ASME Responses to Proposed USNRC Rule Making

**As it affects the
ASME Boiler and Pressure Vessel Code, Section III,
Division 1
Subsection NB-3600, Subsection NC-3600 and
Subsection ND-3600 Piping Design Rules**

February 23, 2004

**STRAIN RATE EVALUATION
of
TEST#37 & JAPANESE COMPONENT TESTS
and
OCCUERENCE of DYNAMIC STRAIN AGING**

ANALYSIS RESULTS TEST#37, RUN5

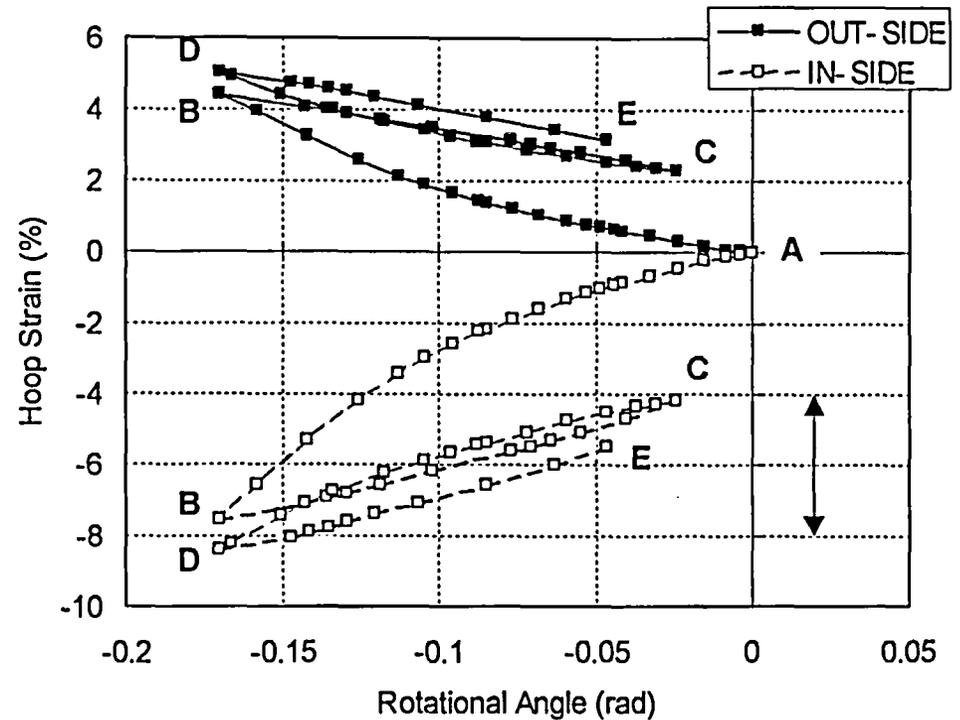
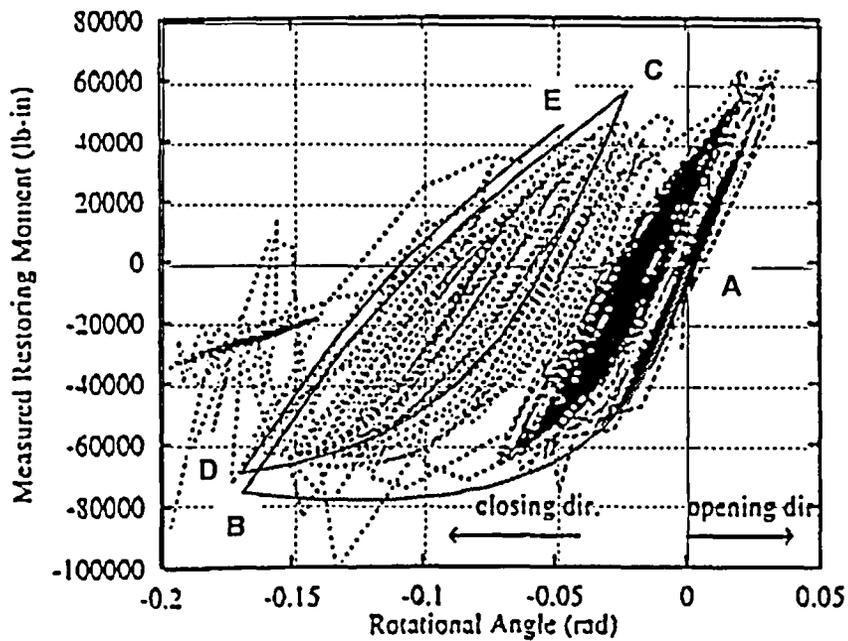
Average strain rate: 0.32/sec. (=0.04/0.125 for 4Hz)

..0.11/sec. (=0.04/0.357 for 1.4Hz; Natural Freq.)

.....Not 2/sec (=Peak strain rate estimated by NRC for 4Hz)

Tensile Property at 288C(550F) vs. Strain Rate for Pipe DP2-F30 (A106 Gr.B)

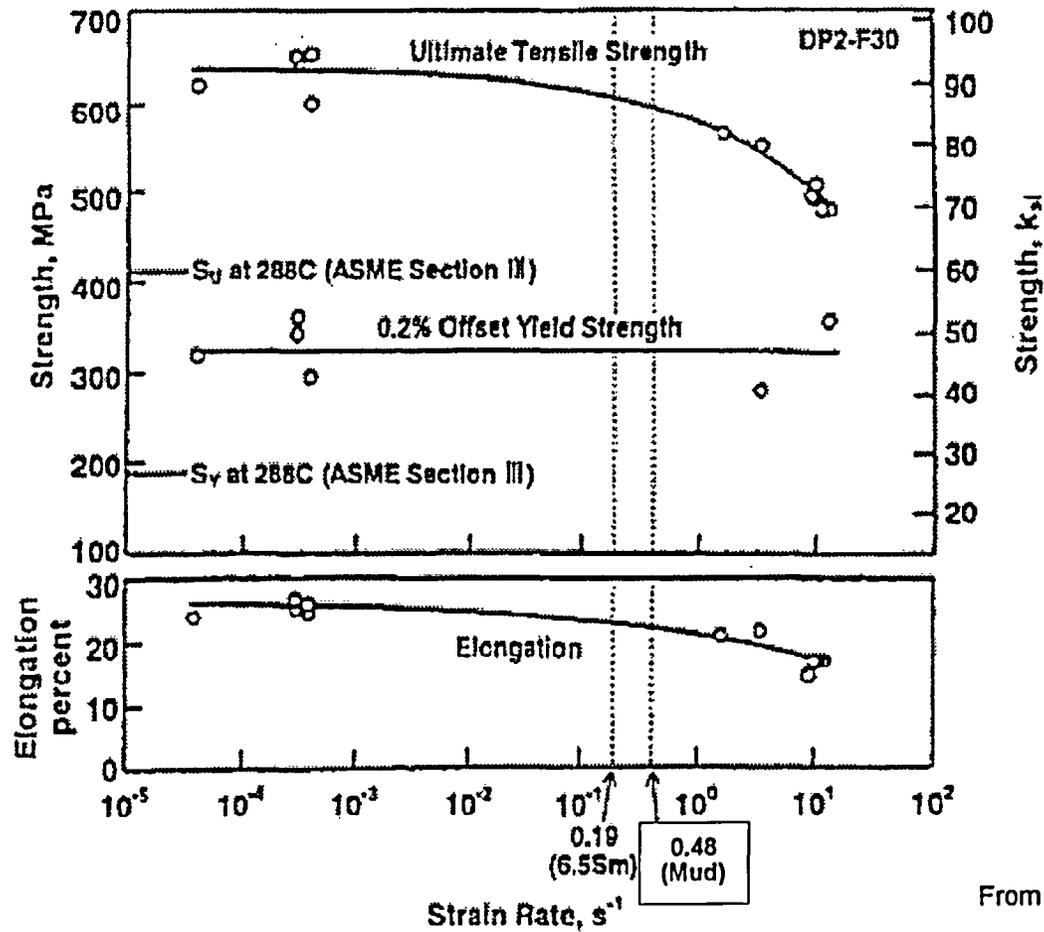
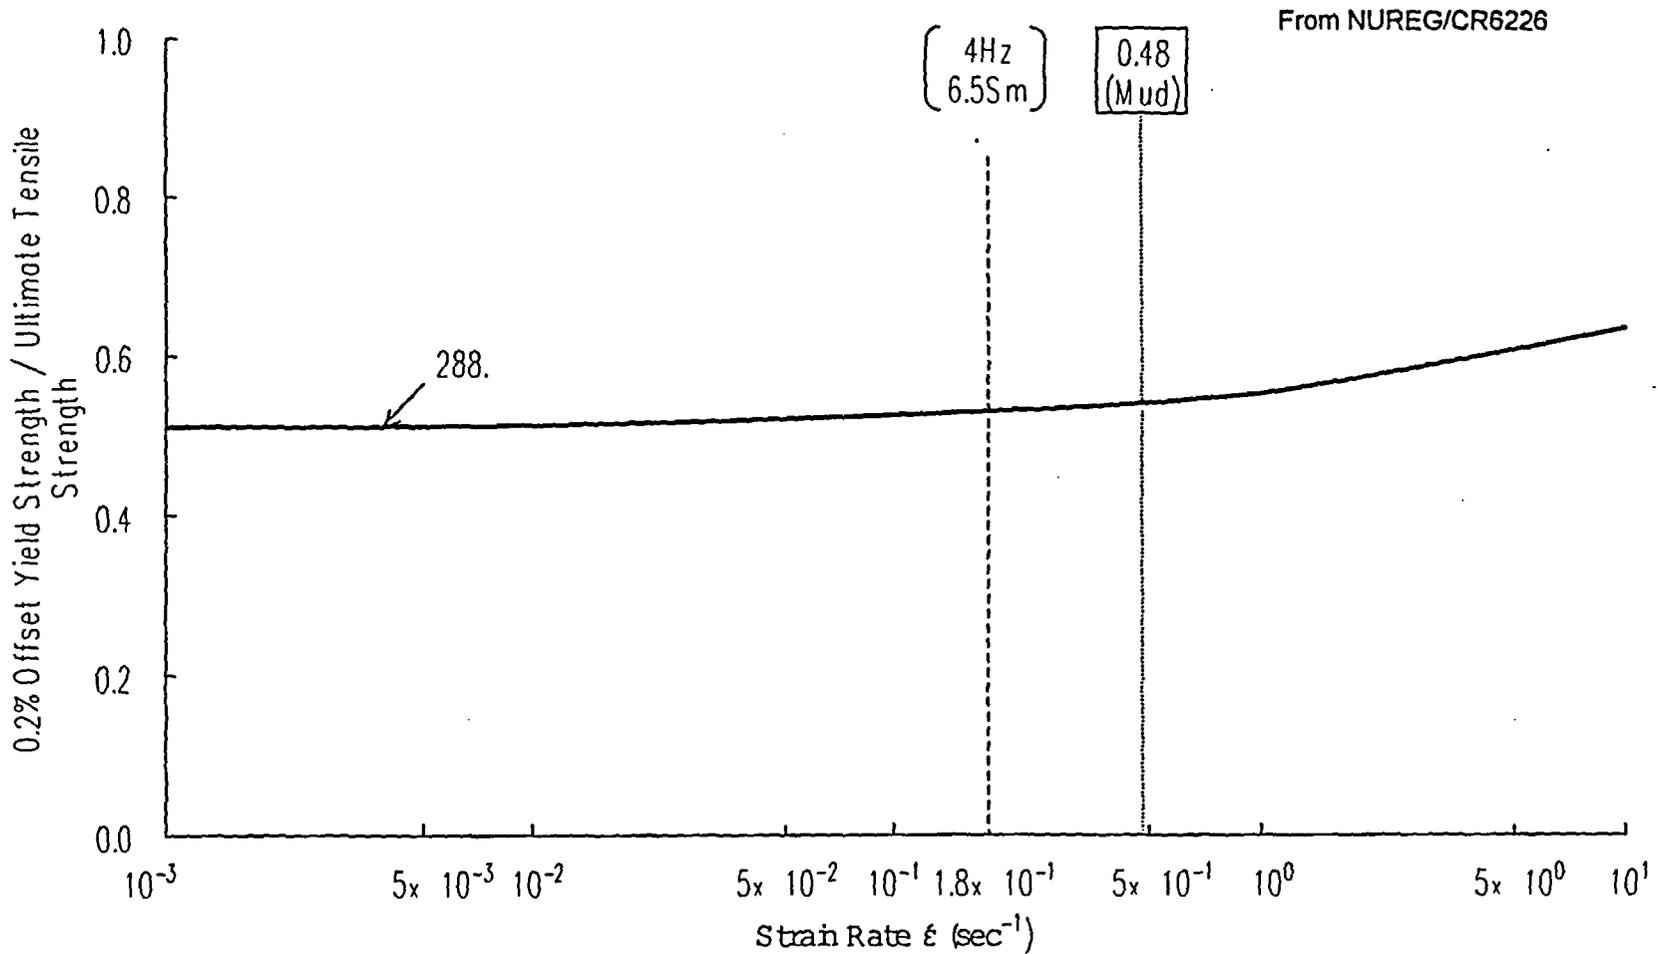
Stress Ratio Change (A106 Grade B)

Figure 4.1
Ratio of OBE g Levels to SSE g Levels
Re-Inforced Concrete Reactor Building

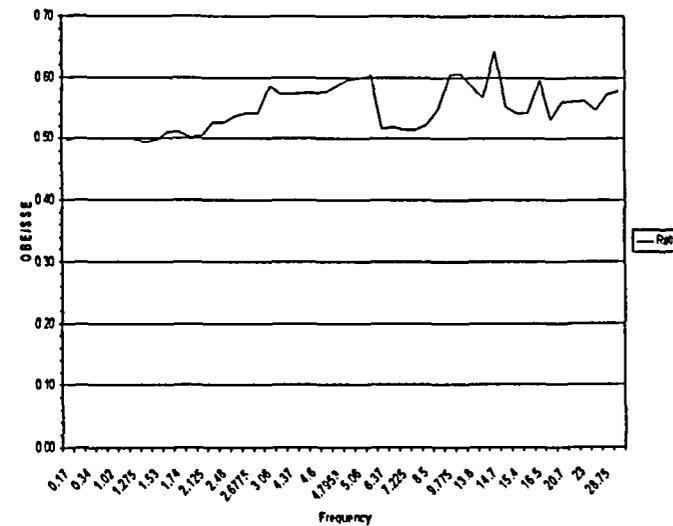
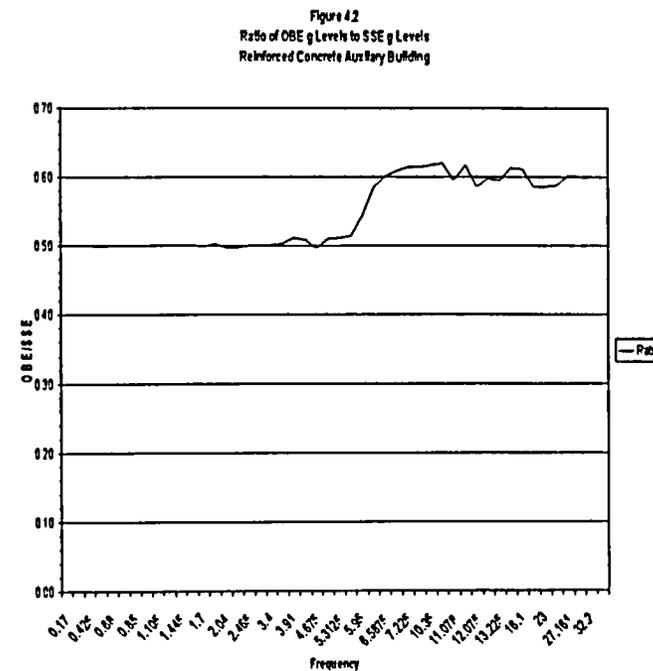
- Ground Motion
 - OBE = 1/2 SSE
 - Reguide 1.60 Spectra
- Reinforced Concrete Building
- Structural Damping
 - Reguide 1.61
 - OBE: 4%, SSE 7%
- Equip Damping
 - OBE, SSE: N-411
- OBE/SSE = .6 or >

- Capacity
 - Initial Margins on Capacity
 - $OBE/SSE = .5$ to $.6$
 - Pressure, Deadweight Reduce Capacity
 - $OBE/SSE = .48$ or $<$
- Demand
 - Damping Causes: $OBE/SSE = .6$
- Capacity $.5$ or $<$, Demand $.6$ or $>$

OBE (Level B) will Control Primary Stress !
